**From:** [REDACTED]  
**To:** [Norfolk Boreas](#)  
**Subject:** Written submission of Open Floor hearing statement by Julian Pearson  
**Date:** 18 November 2019 18:57:27  
**Attachments:** [Boreas-Statement Arquements and images for open Floor hearing.docx](#)

## POINTS OF ARGUMENT AGAINST THE APPLICATION FOR BOREAS.

My comments are based around the substation at Necton and the applicants document "Chapter 29 'landscape and visual Impact assessment'"

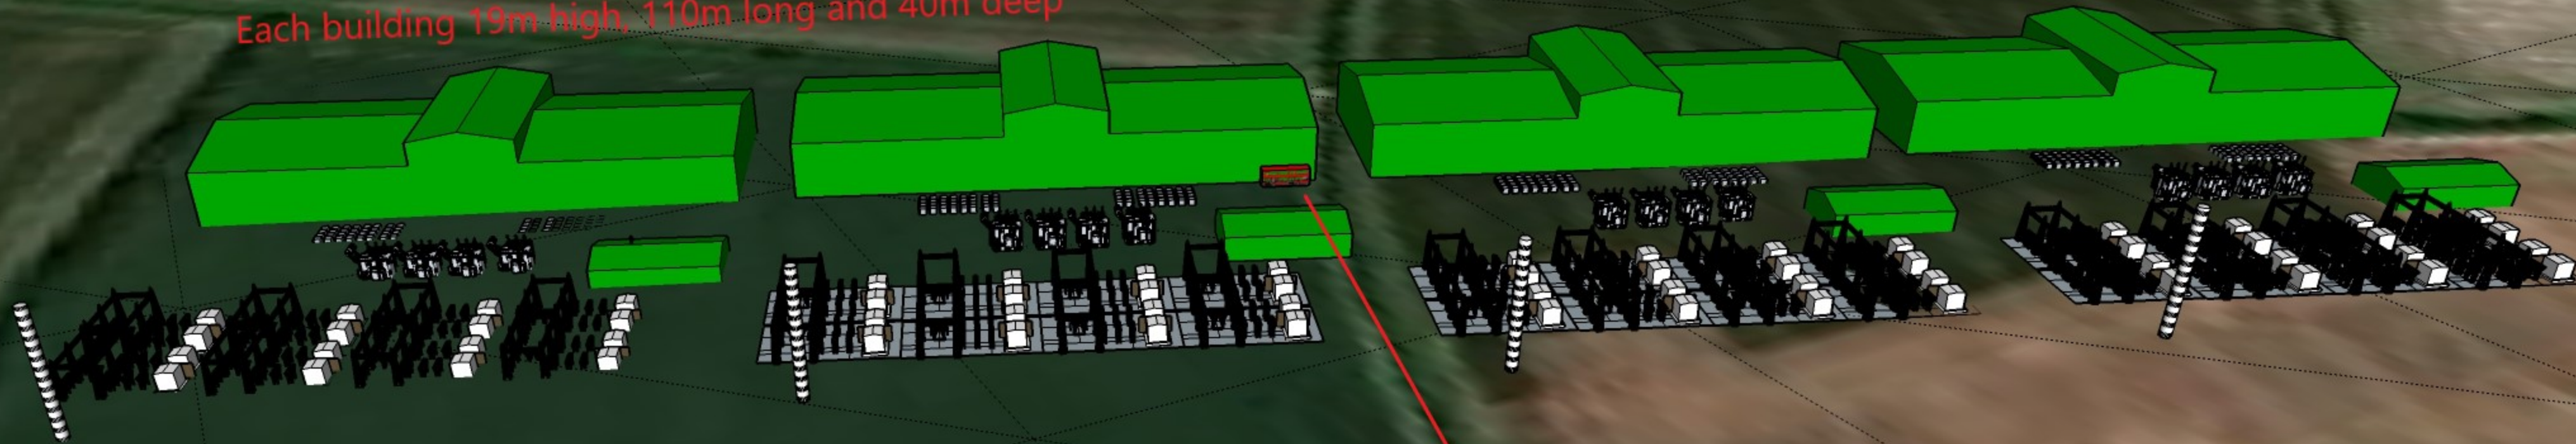
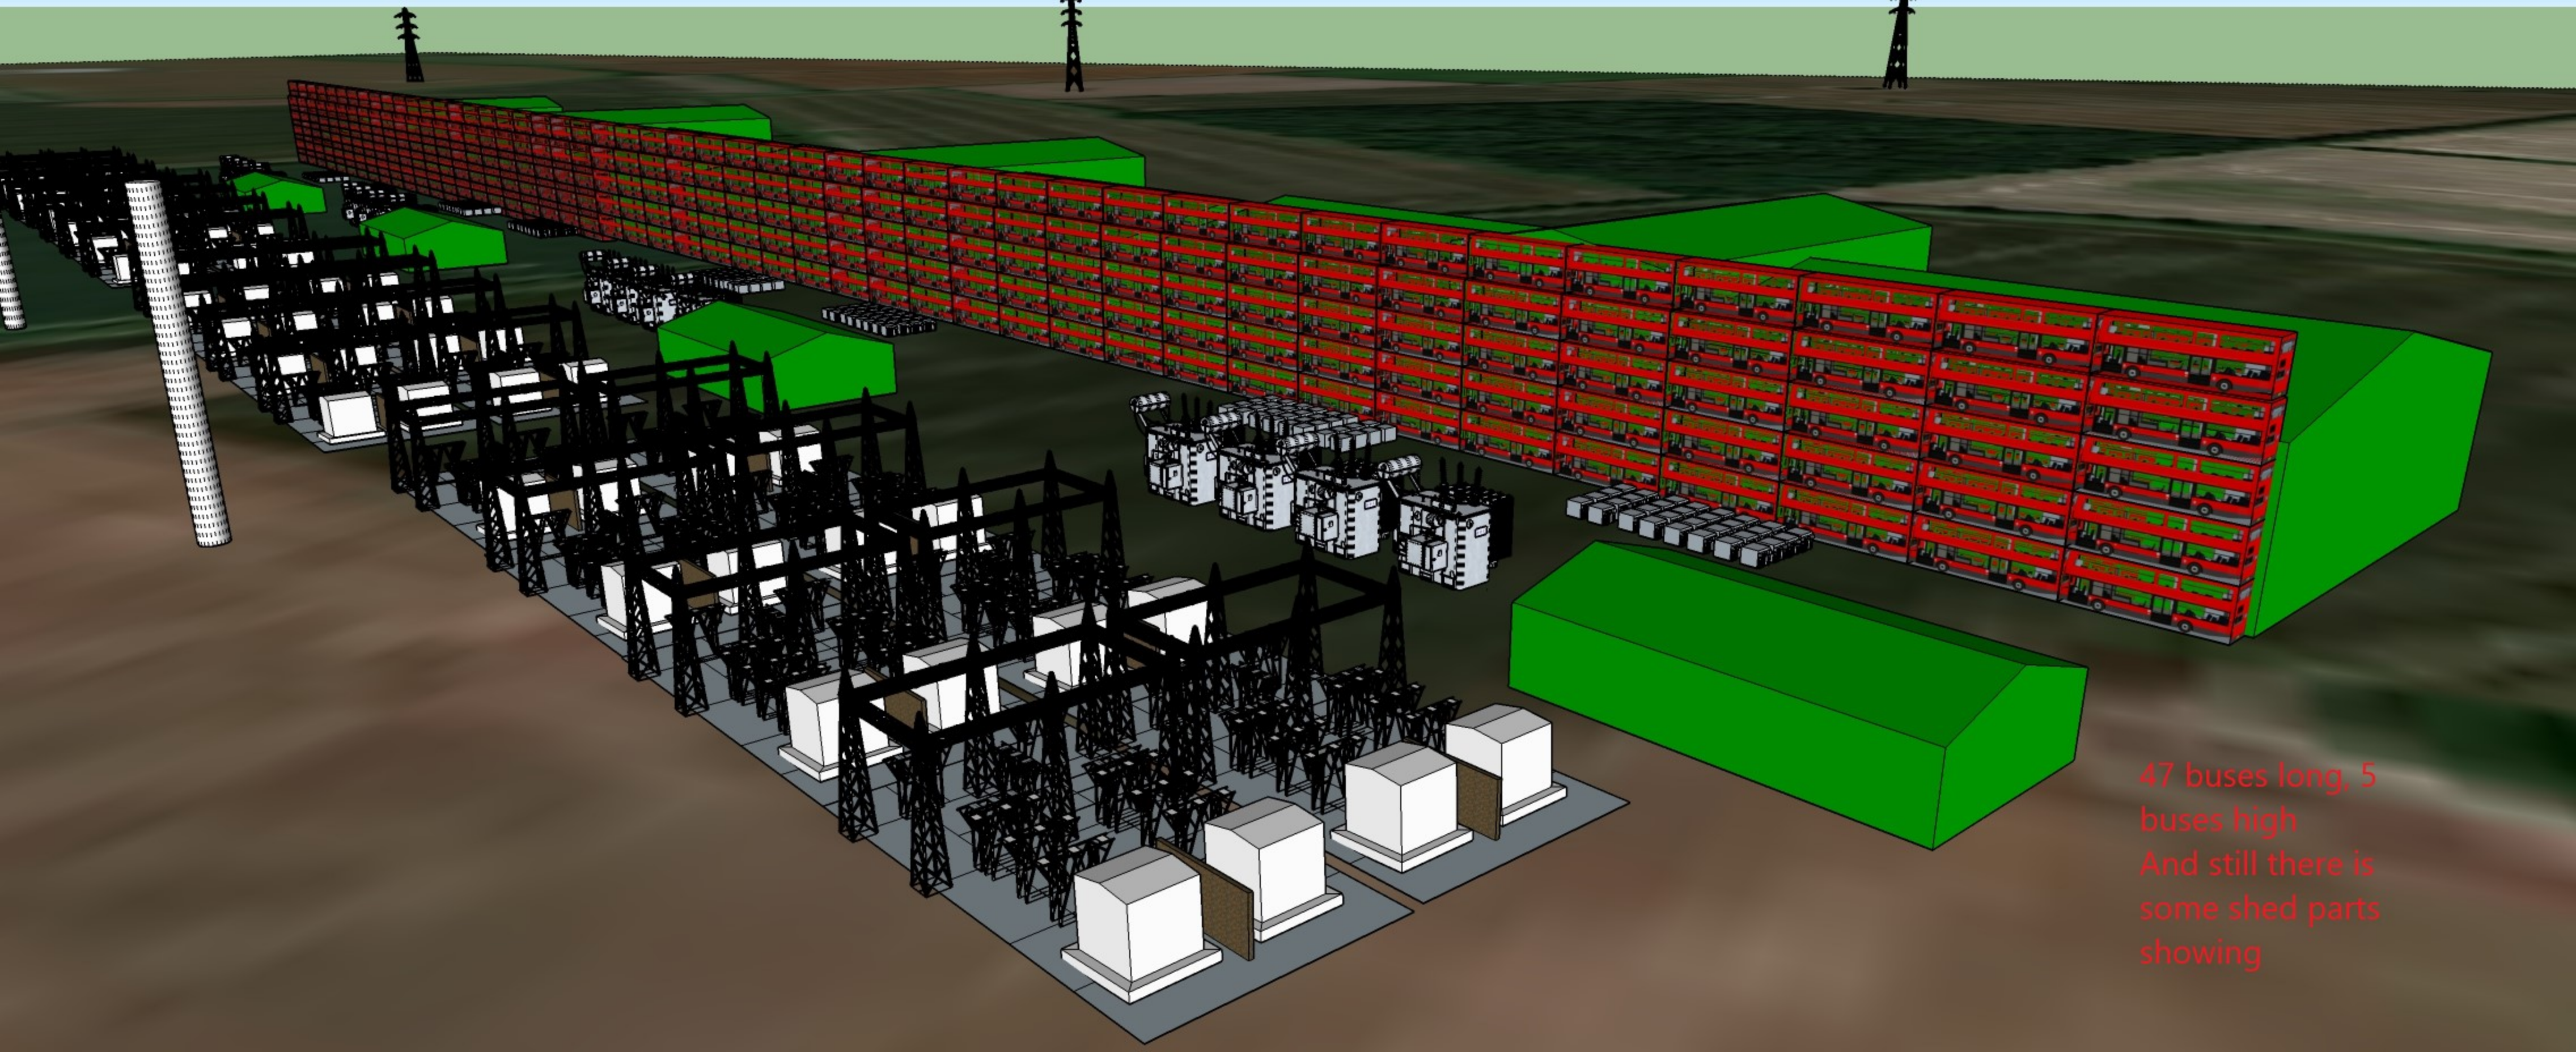
*THREE computer-generated, scale drawings of the combined Vanguard/Boreas development are attached to the email as appendix showing the size of one London double decker bus, parked up against the buildings and the number of said buses it would take, stacked and put nose to tail to conceal the proposed buildings.*

Each building 19m high, 110m long and 40m deep

47 buses long, 5 buses high  
And still there is some shed parts showing

*I therefore respectfully ask that the planning Inspectorate formally request documentation from the applicant for the visual mitigation design outside of the planted landscape, with special attention to addressing the mitigation of these HUGE buildings and provide the reasons as to why no detailed document was not submitted with the application even with caveats.*
